Enclosure 2

Consolidated June 23, 2016 RAI Responses for General Information and Organization & Administration (RAIs 1-12)

Consolidated June 2016 RAI Responses for ISA (RAIs 13-36)

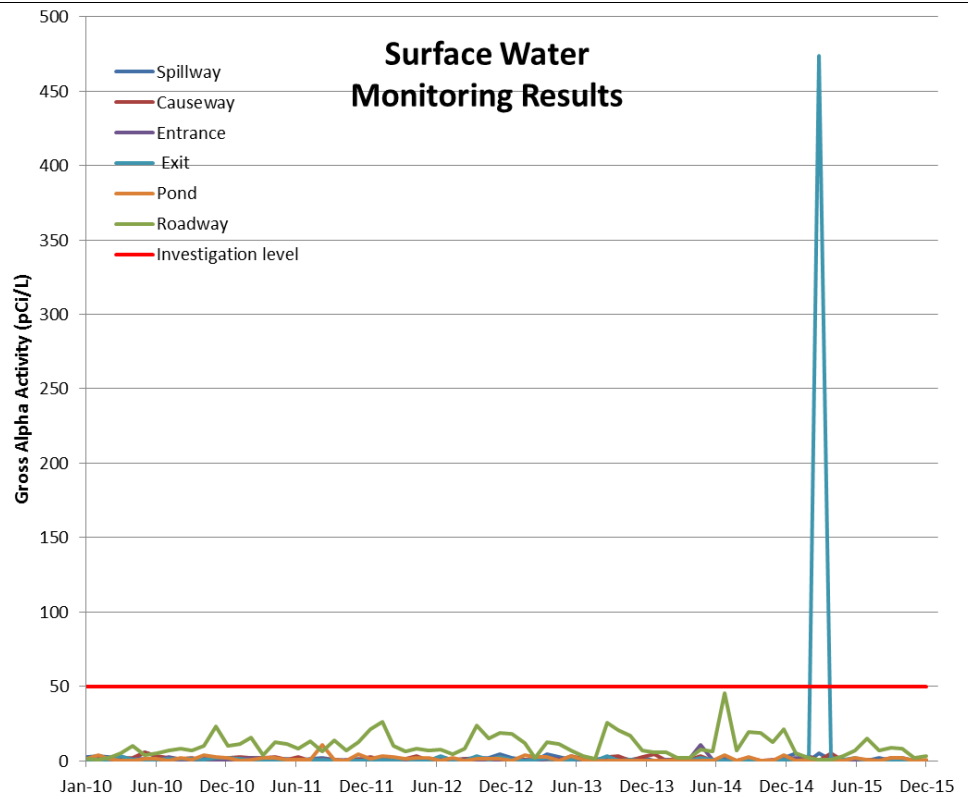
RAI 72 Provide gross alpha monitoring data including exceedances of the maximum contaminant level for ground water and surface water and above	10 CFR Section 51.45.(b)(1), 10 CFR	The maximum contaminant level (MCL) for drinking water is 15 pCi/l, which is the investigation action level for subsequent isotopic uranium analysis at the Westinghouse CFFF per license SNM-1107. Since 2008, the 15 pCi/l MCL has been exceeded six times in NRC wells, as documented in both the table and figure below.

regulatory concern for soil contamination since 2008. Identify the year(s) of occurrence(s), source(s), amount of estimated releases, and location of any gross alpha contamination, and the status of the measures used to identify the source of contamination, and the contaminant elements contributing to the contamination in ground water, surface water, and soil. Discuss ground water and surface water pathways, and the understandings within the conceptual site model of the contaminant plumes, the technical basis of gross alpha contamination to the drinking water sources, potable water wells south of the site, and the environmental impacts on ground water, surface water, and soil resources due to gross alpha contamination for the proposed action and no-action alternative.

Note only the exceedances are listed below:

Well 7	26 March 2009		
Well 13	17 Sept 2011	18 December 2011	
Well 23	25 Sept 2010	47 November 2010	19 June 2011
